SERVICE BULLETIN

CHECK OF ALLEN SCREW M8X100 IN THE CRANKCASE ON ROTAX® ENGINE TYPE 912/914 SB-912-047 SB-914-032

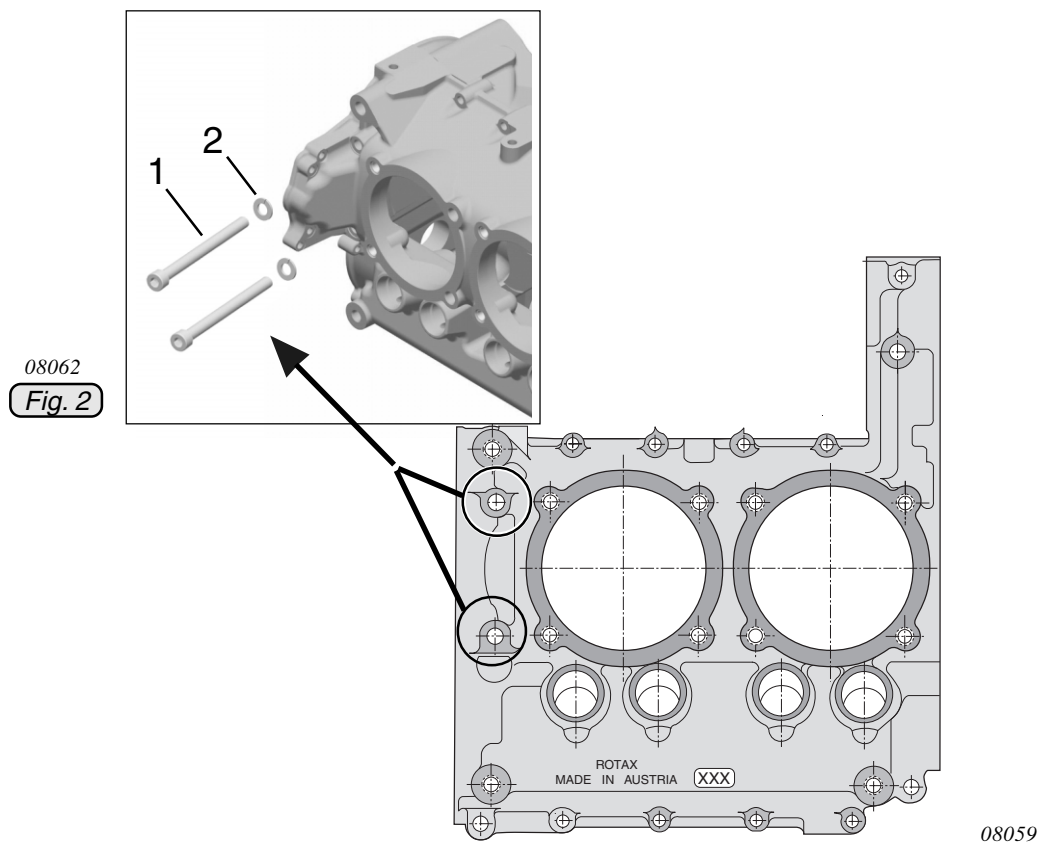
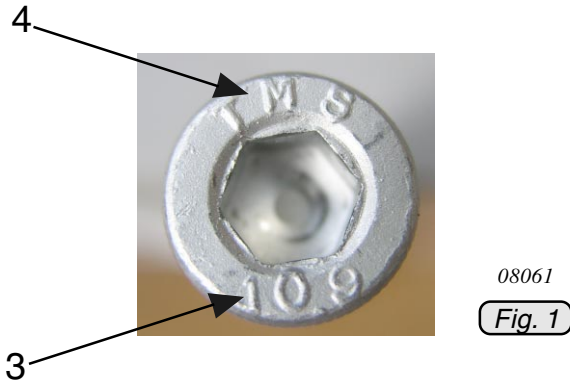
Only the 2 allen screws M8X100 (1) part no. 440427 are affected by the production deviation. They are installed in the crankcase on the cylinder side 1/3 between cylinder 3 and the electric starter.

Furthermore, only allen screws marked „TMS“ on the screw head are affected.

◆ **NOTE:** In addition to the quality marking 10.9 (3) the production code must be identified on the screw head. Allen screws with a production code of „TMS“ (4) may be affected and must be replaced in all cases.

- Replace affected allen screw (1) including lock washer (2). Tightening torque 30 Nm (265 in.lb.).

■ **CAUTION:** If both allen screws are affected and must be replaced, allen screws and lock washers must be replaced one at a time. Remove and replace the first allen screw and lock washer before loosening or removing the second screw. After the first screw and lock washer has been replaced, remove the second allen screw and install a new allen screw and lock washer.
